COOPER RIVER REDIVERSION PROJECT
LAKE MOULTRIE & SANTEE RIVER
SOUTH CAROLINA

WATER
MONITORING PLAN

SUBJECT: Cooper River Rediversion Project, Design Memorandum 15, Water Quality Monitoring Plan

1. The Design Memorandum is approved subject to the following comments:

MONITORING
EQUIPMENT ARRANGEMENT

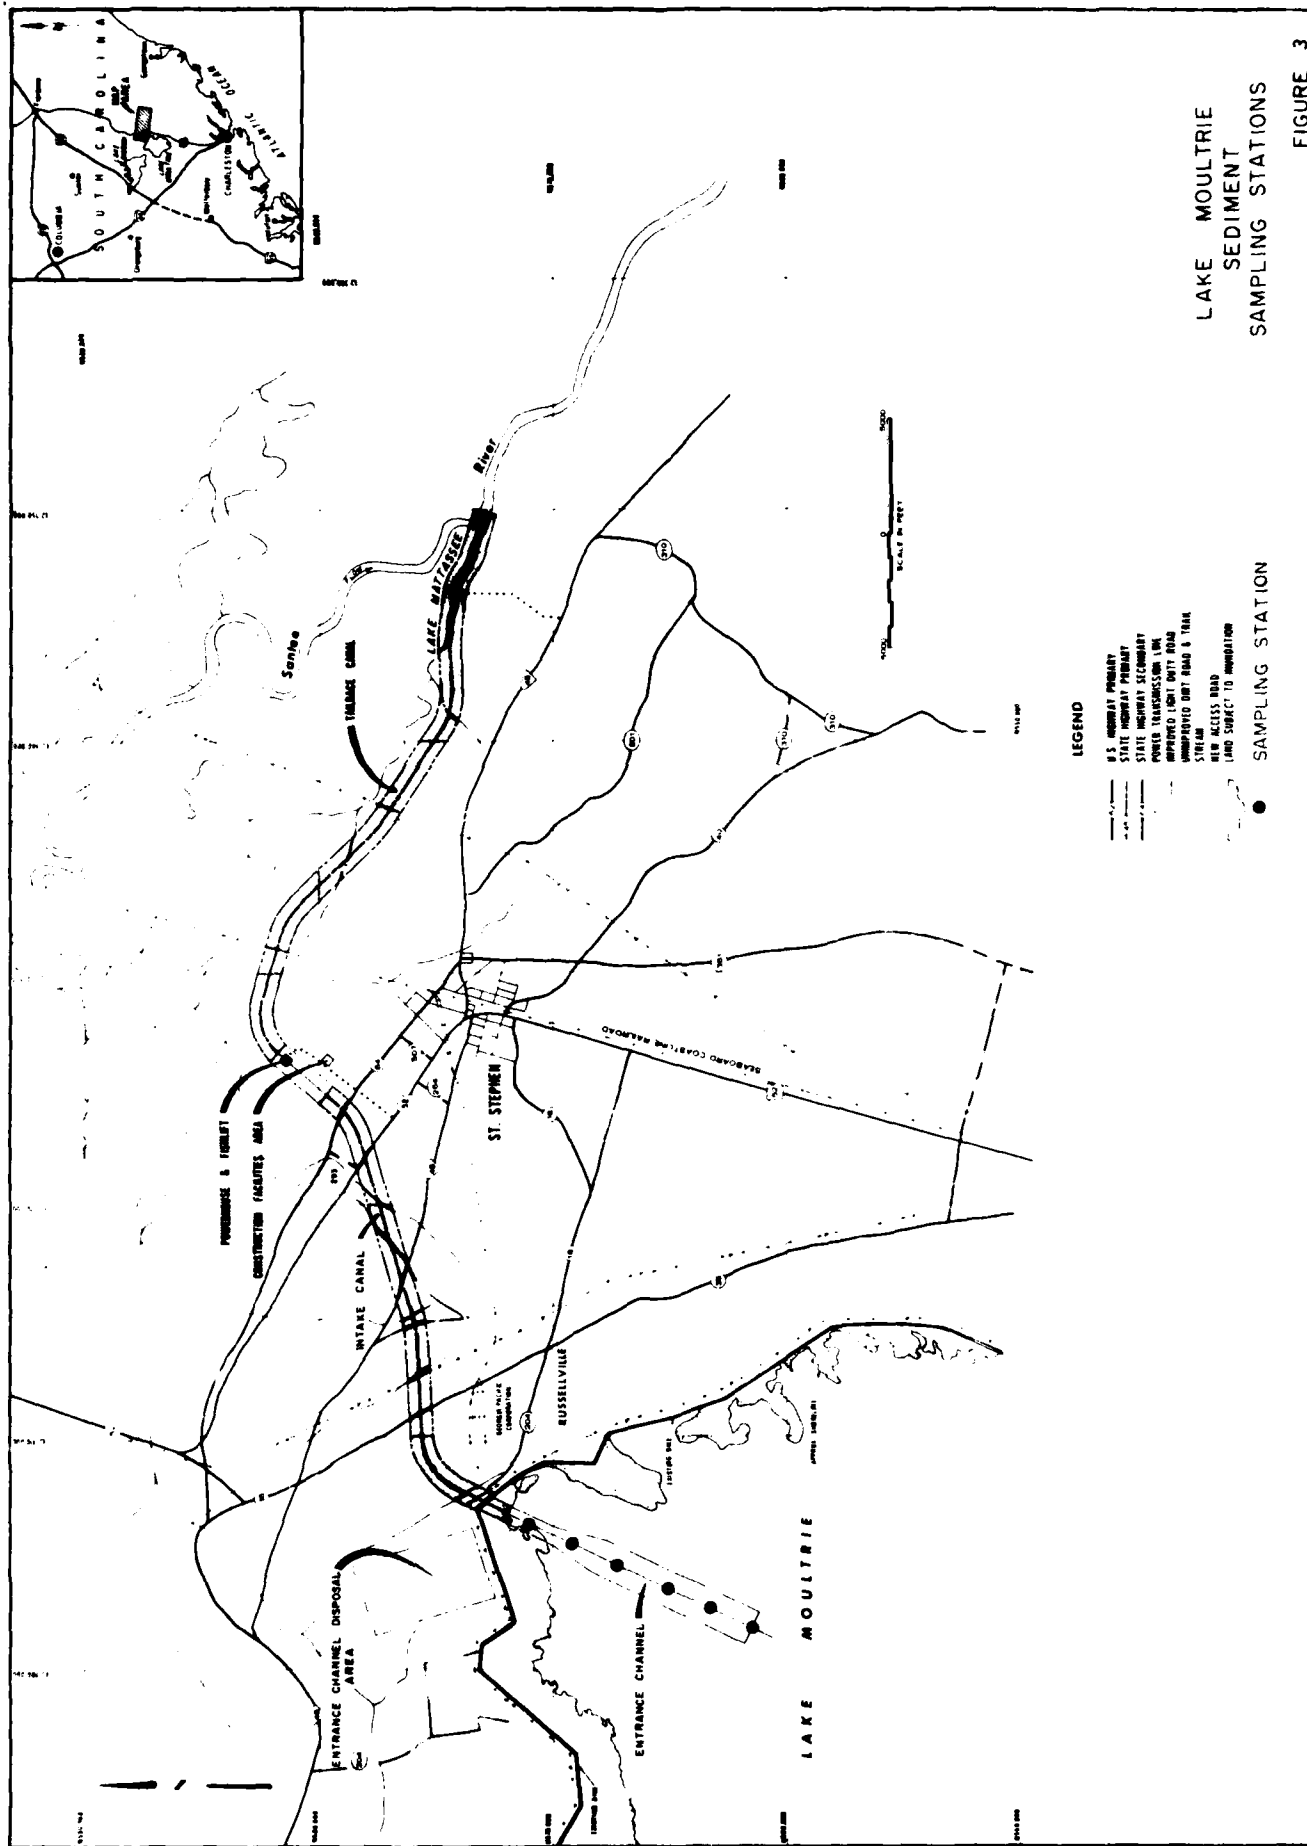
h. In order to insure earlier detection of possible salinity, the intake for Durham Canal monitor should be located at mid-depth in lieu of upper level.

9. Paragraph h. Since the salt wedge tends to move along the bottom, the intake for the Durham Canal monitor will have a bottom intake.

U.S. ARMY ENGINEER DISTRICT, CHARLESTON CORPS OF ENGINEERS CHARLESTON, SOUTH CAROLINA		
WATER QUALITY MONITORING PROGRAM		
SCALE AS SHOWN	DM 15 WATER	PLATE 1
DATE MAR 78	MONITORING PLAN	FILE NO 10082

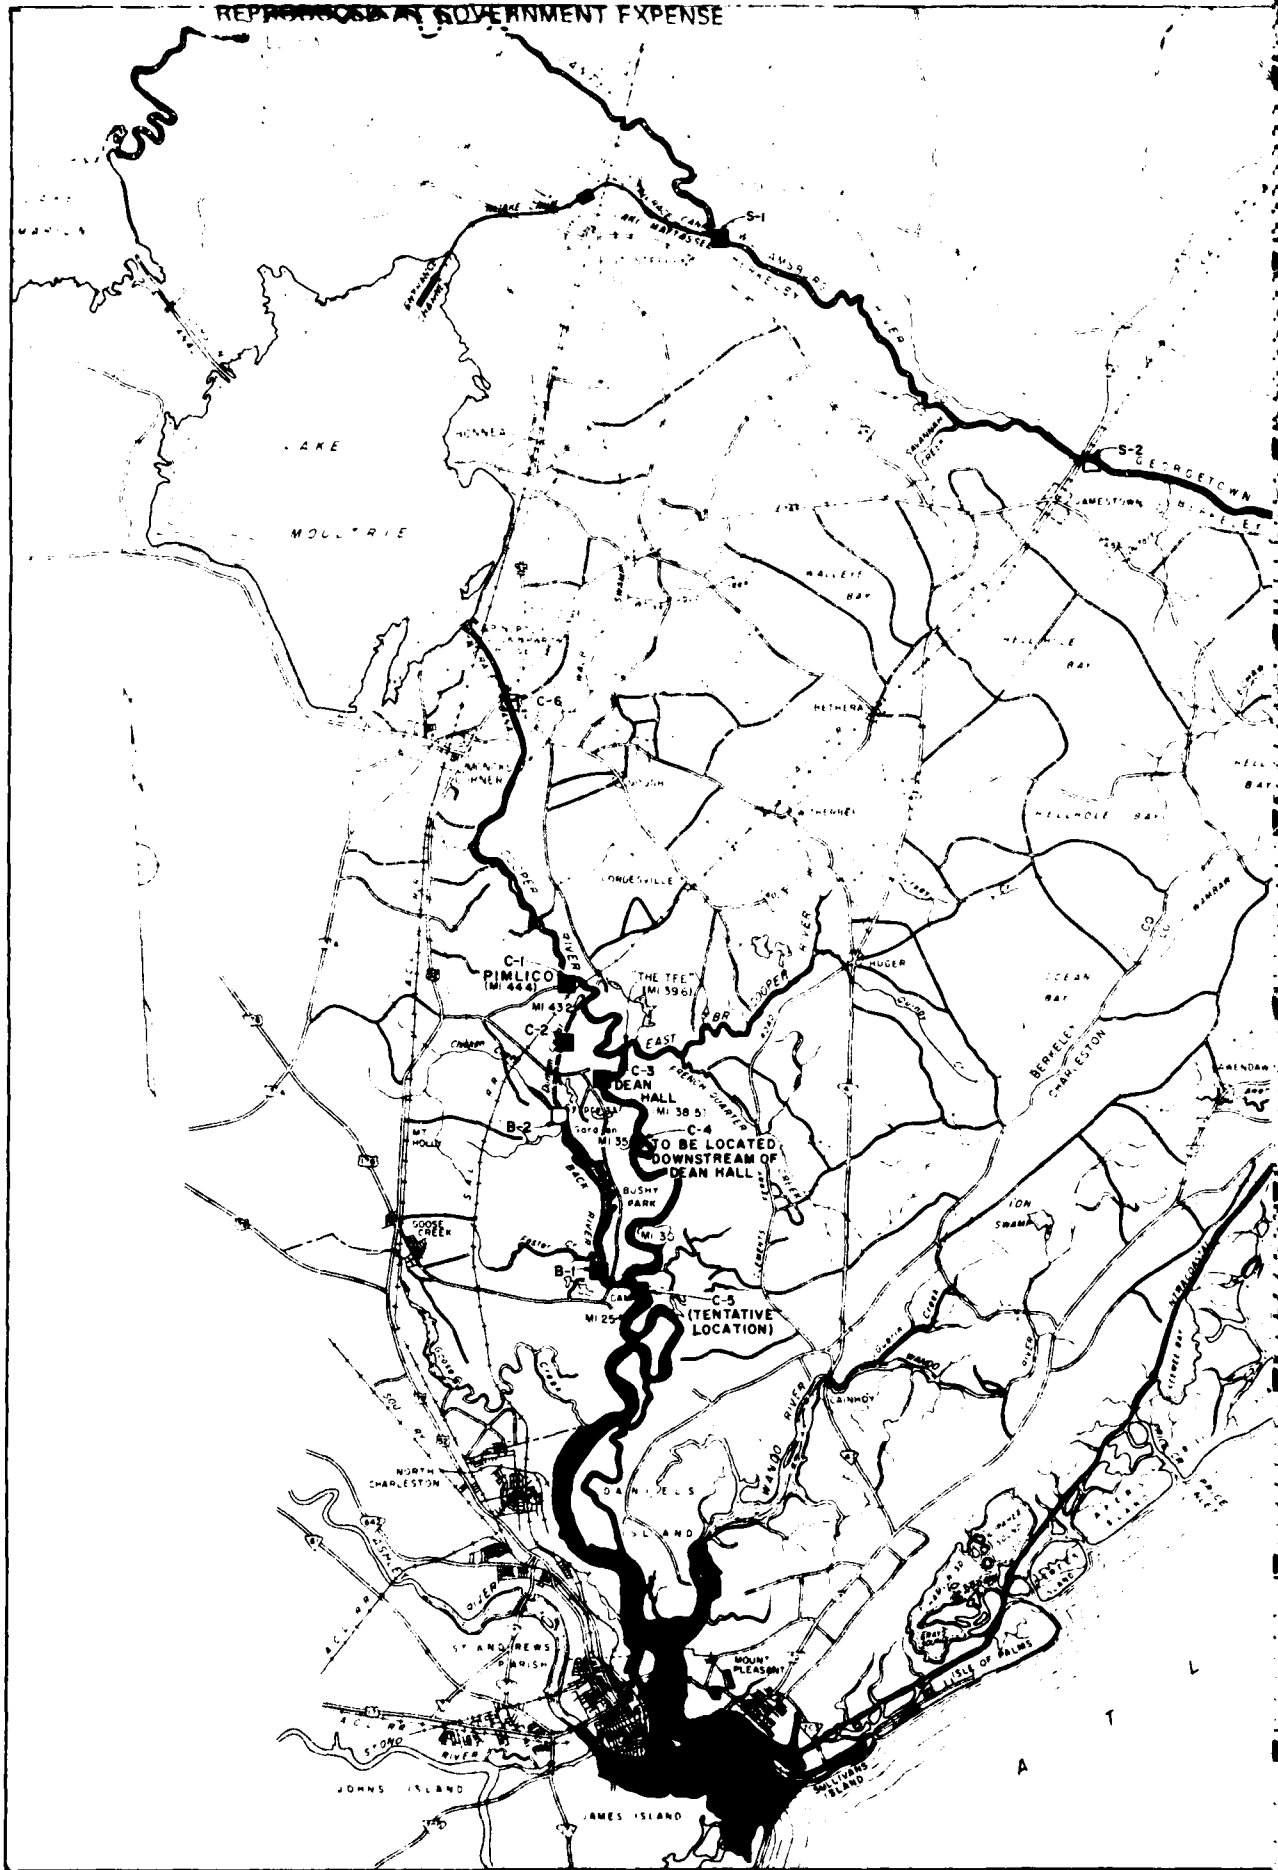
a. Page 4, paragraph 8. Water use classification. Suggest using a single line drawing in addition to this paragraph to show classification and relation to tributaries similar to attached drawing.

b. Page 11, paragraph 11. Environmental Protection Agency, (EPA) 1974. The maximum penetration (between mile 33.2 and 33.5) should be shown on a map of the area, i.e., plate 1. River mile 42, discussed in succeeding paragraph 13 should also be shown.

j. River mile locations should be shown on the plates and figures since they are frequently referenced in the DM.

2. Paragraph a. Included in Plate 1.
3. Paragraph b. River mileage has been added to Plate 1. Mileage figures shown in the report and on Plate 1 correspond to the same location given in the EPA report although the mileages are different.

11. Paragraph j. River miles have been included in Plate 1.
